STATE OF NORTH CAROLINA
DEPARTMENT OF TRANSPORTATION

Subject: Signal Head Approach Displays

Please find attached revised pages on the subject matter for the Traffic Management & Signal Systems Design Manual.

Signal Head Approach Displays and Alignment

CASE 11

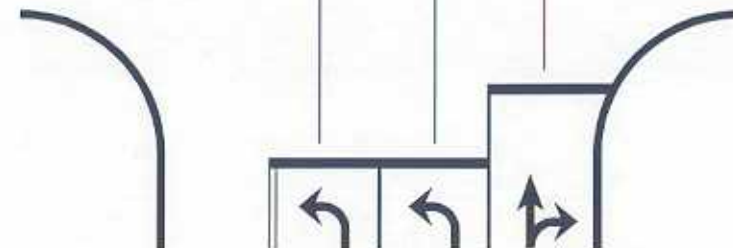
These revisions reflect the recent interpretation by the Federal Highway Administration that when the through movement is a minor movement, Section 4D.15 still requires two separate displays for the through movement in addition to the two signal faces for the major movement (see attachment). This interpretation affects Cases 11, 13AR, 30, and 33AR of Standard Number 3.2.

In consideration of all of the applicable statements in Chapter 4D and the needs of road users, it is our interpretation that item A of the second Standard statement in Section 4D.15 is intended to require a minimum of two signal faces to control the through movement on all approaches that have a through movement. Where a through movement does not exist on an approach (such as on the stem of a "T" intersection), a minimum of two signal faces shall be provided for the turning movement that is considered to be the major movement from the approach.
